GROUNDWATER MONITORING PLAN
COMMENT/RESPONSE REPORT
LENA ROAD LANDFILL
PERMIT NUMBER 5041-211176
BRADENTON, MANATEE COUNTY, FLORIDA
PSI PROJECT NO. 378-4L015

Re: Groundwater Monitoring Plan
Comment/Response Addendum Report
Lena Road Landfill
Permit Number 5041-211176
Bradenton, Manatee County, Florida
PSI Project Number: 378-4L015

**GROUNDWATER MONITORING PLAN
COMMENT/RESPONSE ADDENDUM REPORT
LENA ROAD LANDFILL
PERMIT NUMBER 5041-211176
BRADENTON, MANATEE COUNTY, FLORIDA**

DATE FEB 95 PROJ. NO. 378-4L015 FIGURE 14

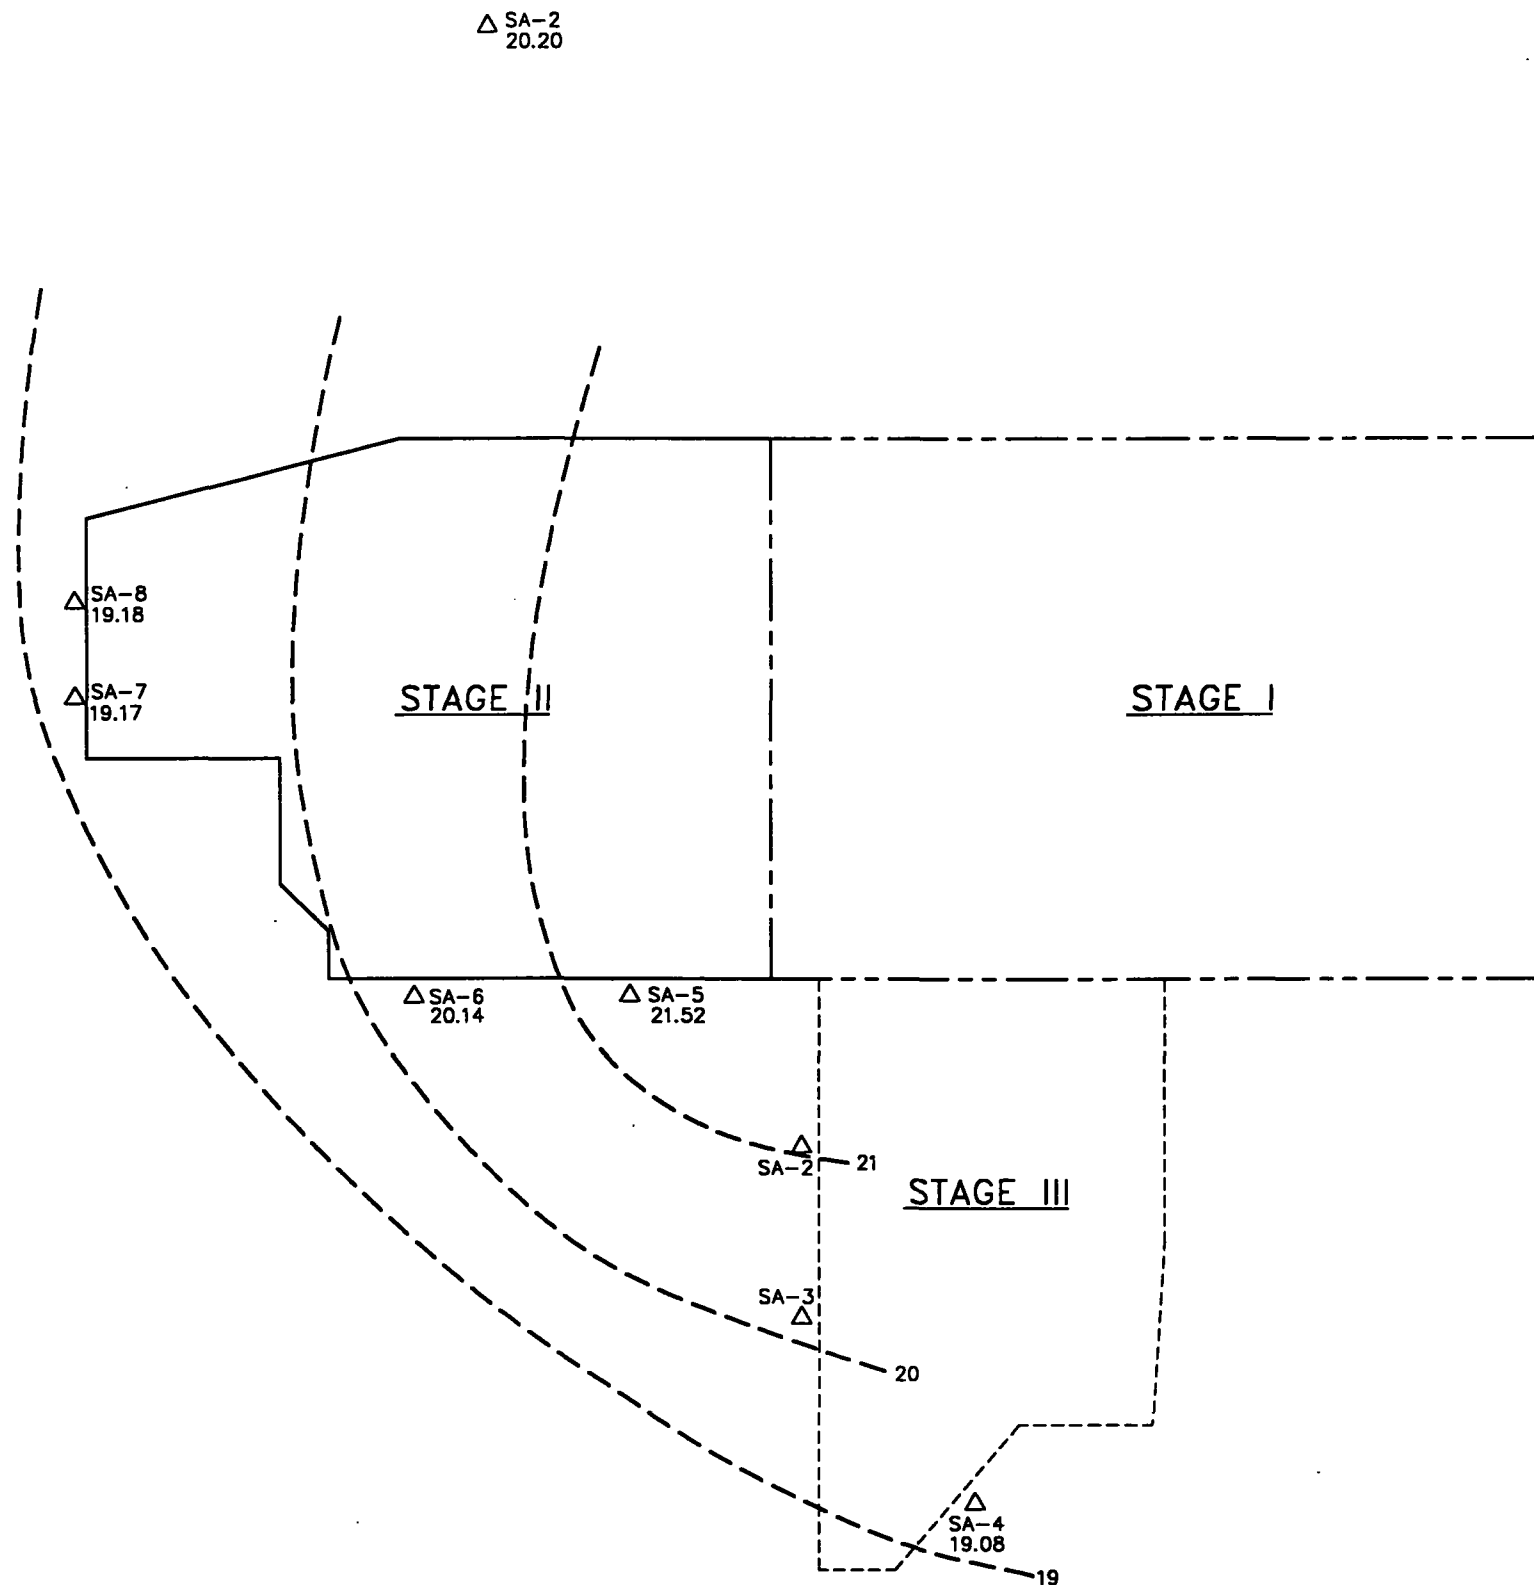
- Map with the location of the deep wells.
- Groundwater flow in the deep aquifer.
- Vertical gradient at the site.
- Map showing the location of all the filled areas inside, and outside of the slurry wall. From discussions with Greg Yekaitis, Manatee County Solid Waste Administrator, there are old waste-filled areas outside of the slurry wall that may impact the current facility's groundwater monitoring program.
- In addition, a base map showing the location of all wells would be useful.

- A map with the location of the deep wells is provided in Appendix C, Figure 2, of this report.
- PSI has evaluated the data concerning the deep wells at the Lena Road Landfill and interpret the direction of groundwater flow to be to the north-northwest. There is a general trend for the high point to be in the vicinity of deep monitoring well SA-5, and for the low points to be in the area of deep monitoring wells SA-4, SA-7, and SA-8. The data is limited to the six (6) similarly constructed wells and is meant to give a rough estimate of groundwater flow direction. This data does correlate well with the regional trend of groundwater flow published by Southwest Florida Water Management District. Groundwater contour maps for the deep monitoring wells are provided in Appendix C, Figures 8-15 of this report.

**MONITORING WELL CONSTRUCTION DETAILS
FOR GC-1A AND CW-5A**

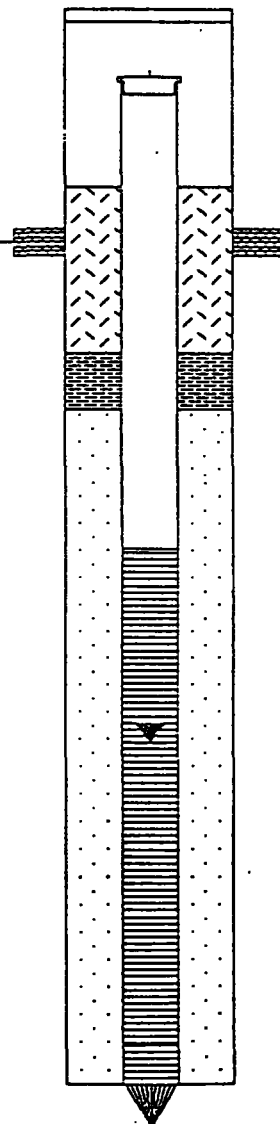
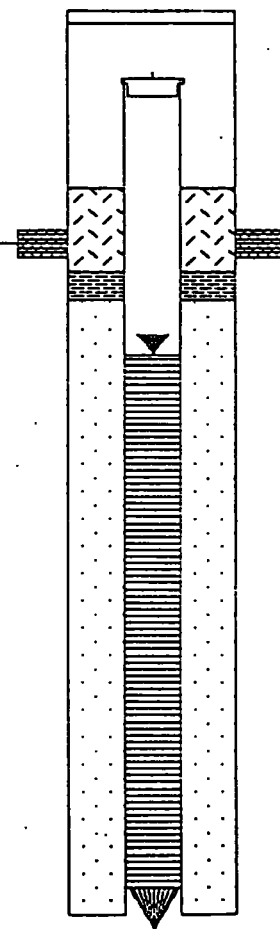
The monitoring well installation construction details approved by the FDEP for wells GC-1A and CW-5A were for an 8-inch borehole diameter. The boring log/well construction diagrams show a 4-inch borehole for each well, constructed by a 4.25-inch inside diameter hollow-stem auger. Please correct this discrepancy.

Comment noted; changes have been made (Appendix D).
